ADDENDUM #1

Job #: 190970 **Project Title** Alexandria Lower Dam Improvements
Client: City of Alexandria

Issue Date: February 16, 2023
Bid Date: February 21, 2023

**PLAN SHEET 3
OVERALL SITE**

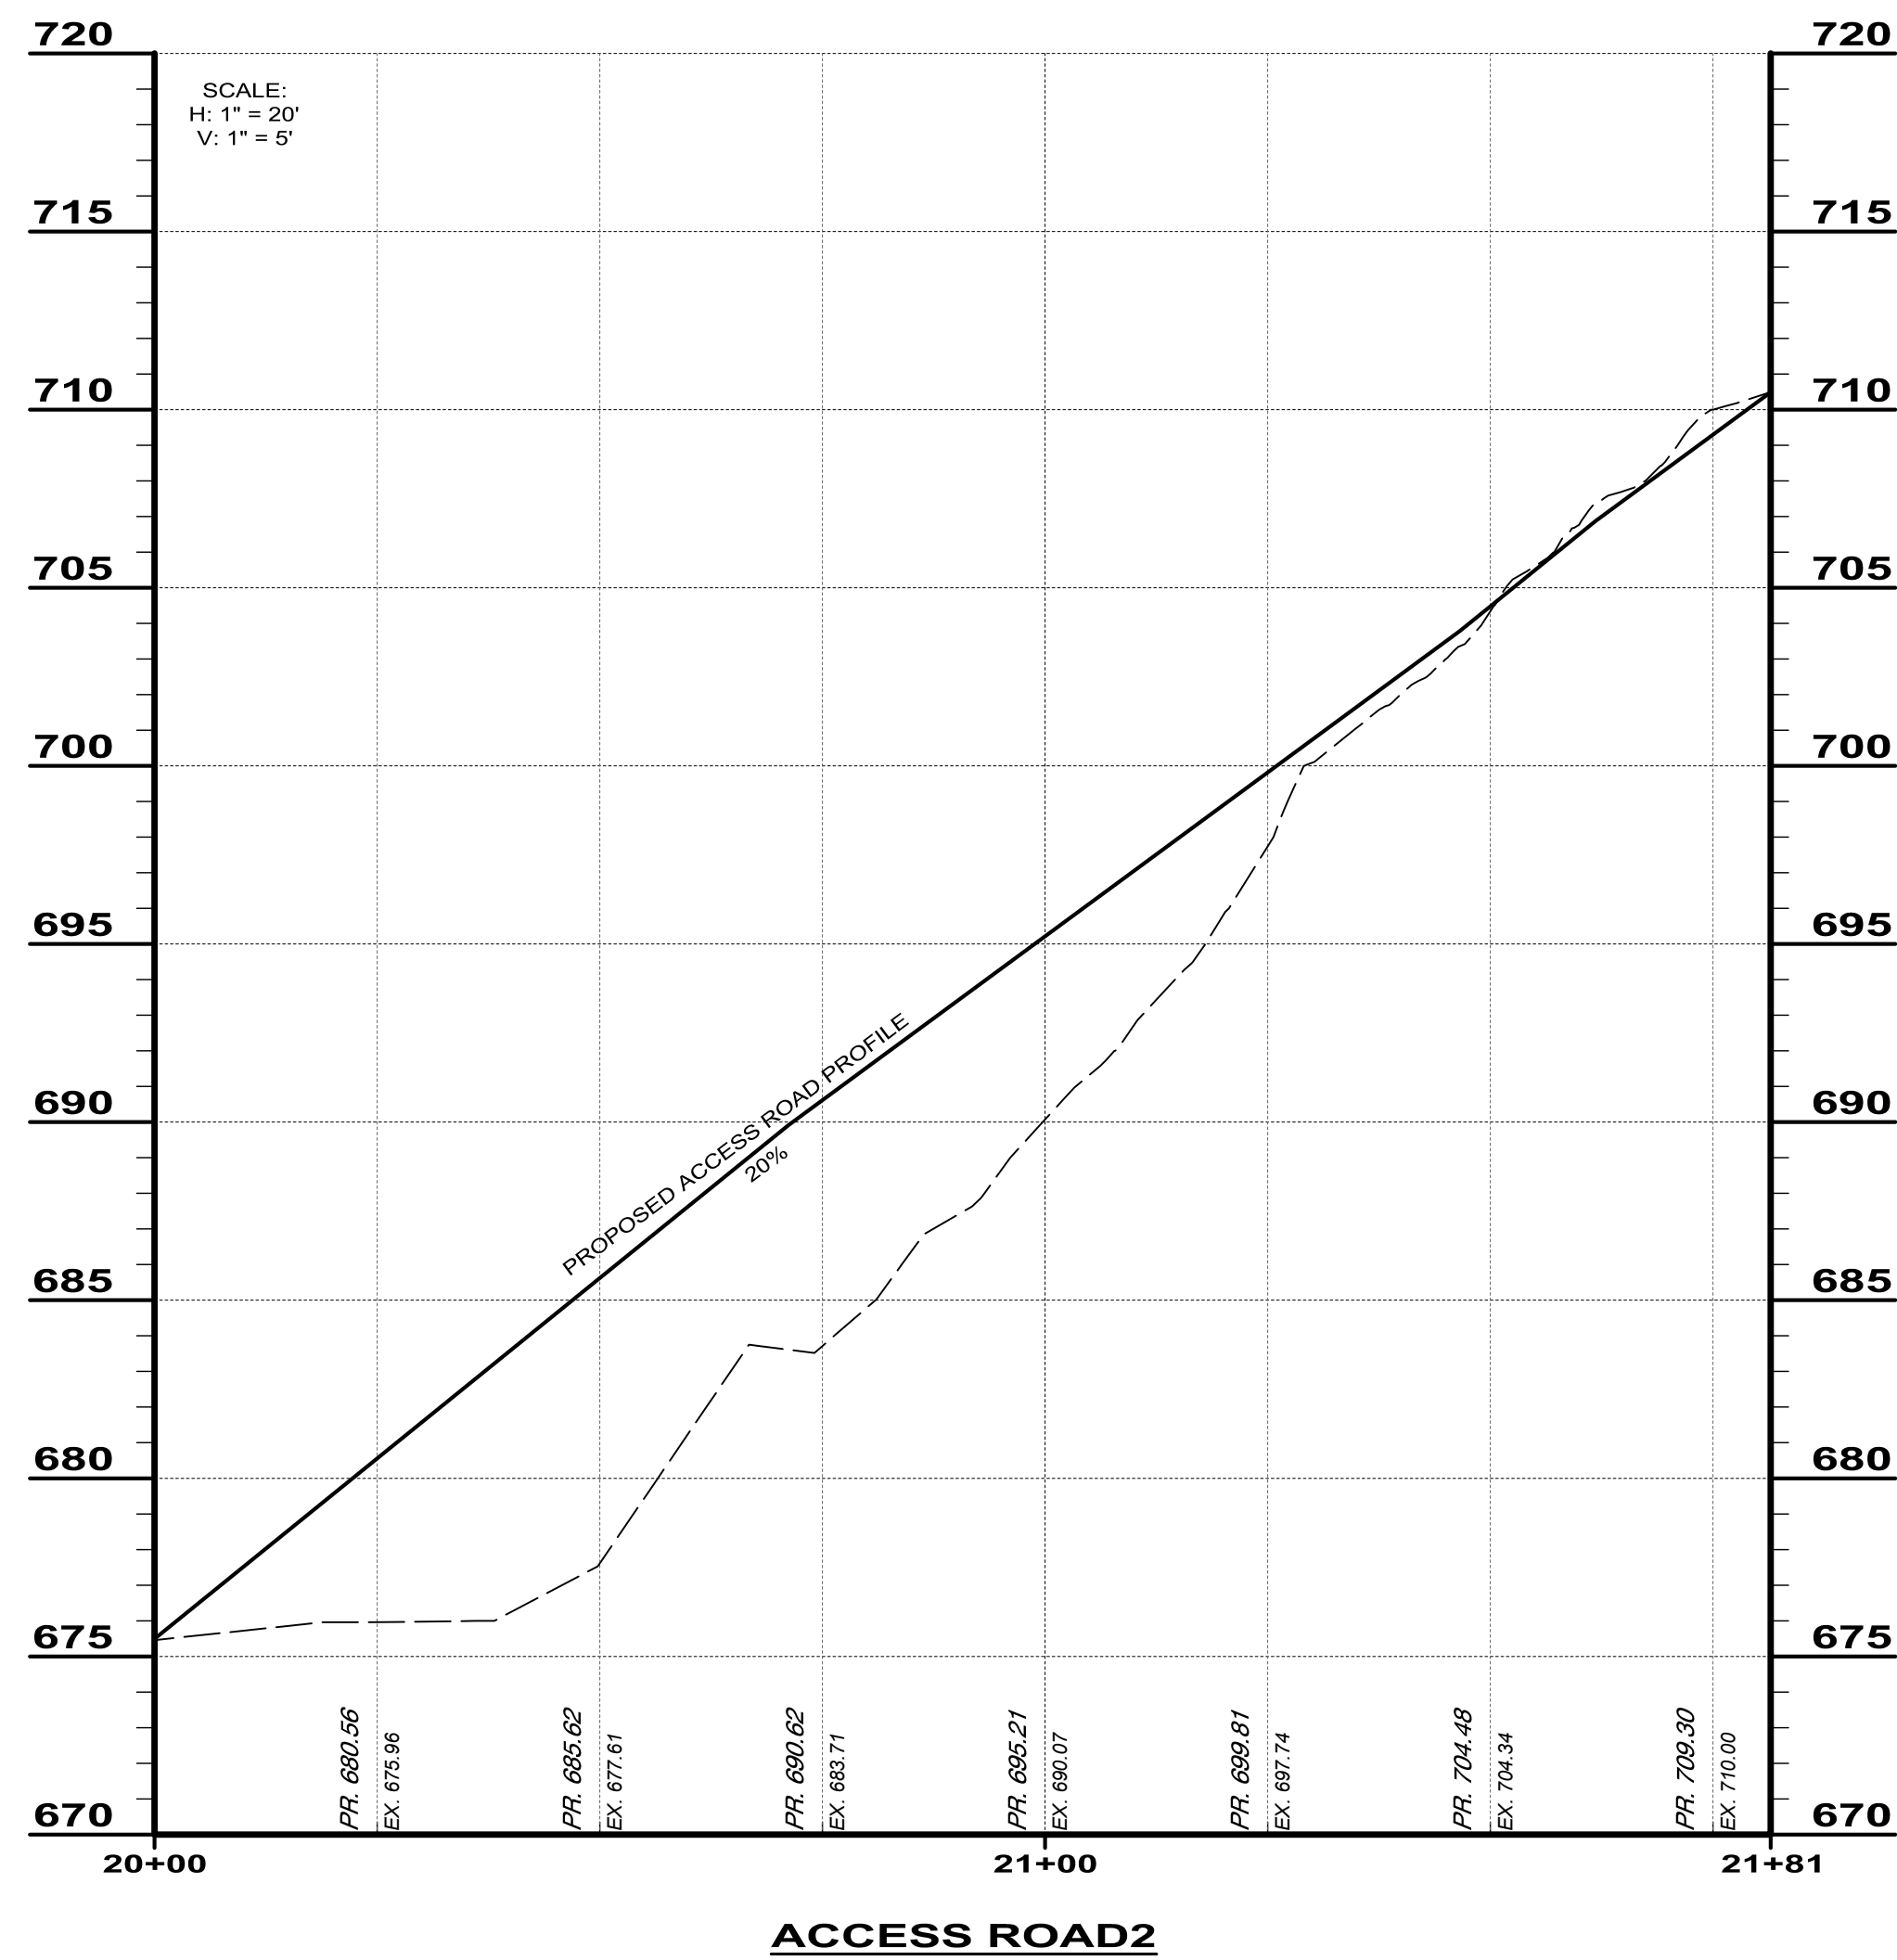
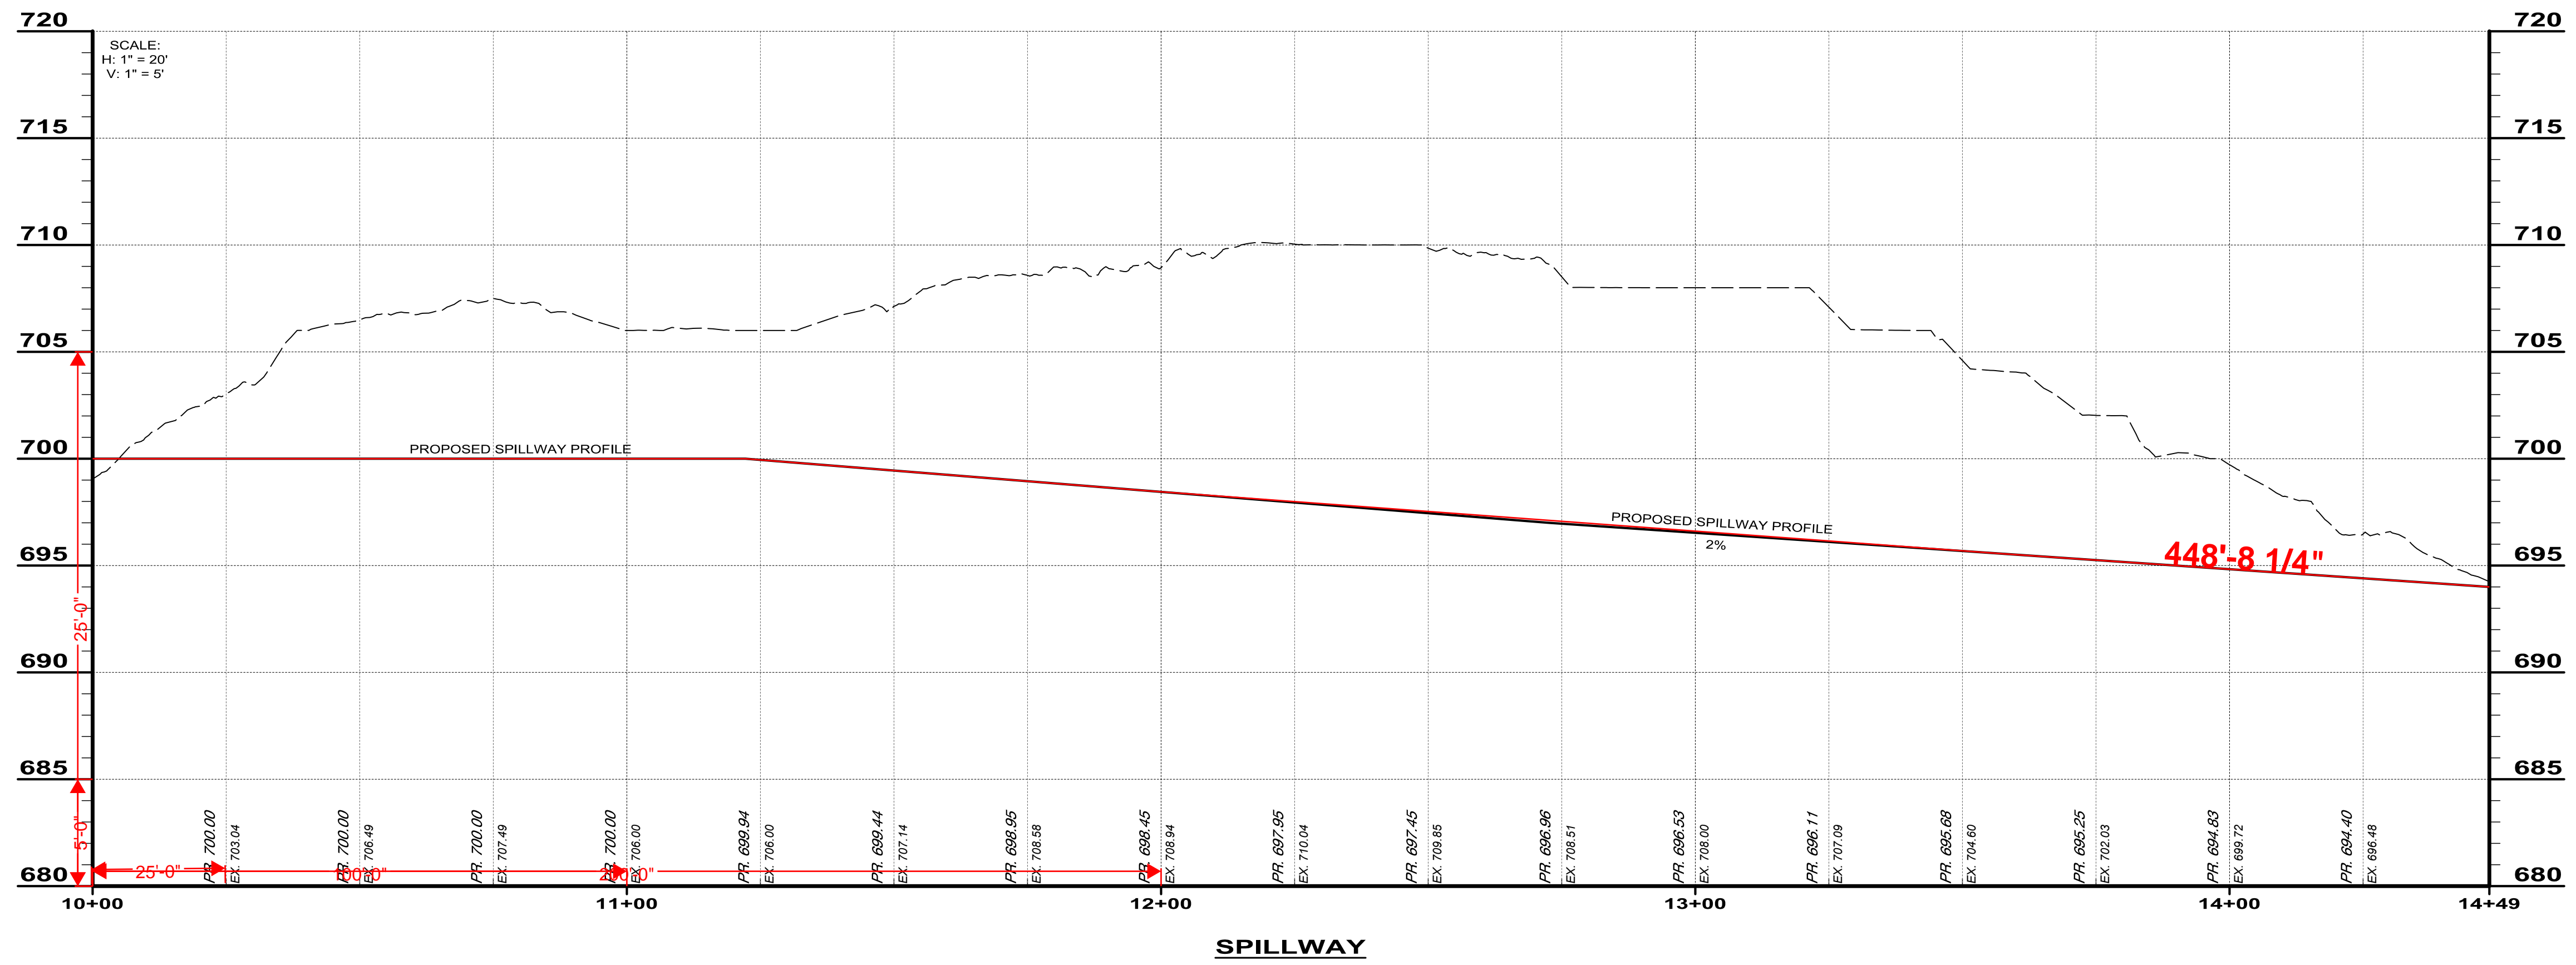
Geogrid and Curlex II extensions on 15.5' wide roll. Install adjacent mat over extensions and secure with U anchors in 2' increments.

18" Perpendicular Overlap Seam, soil infill and seed, secure with U Anchors in 2' increments.

Initial leading edge needs to extend 3' down the inside face of dam.
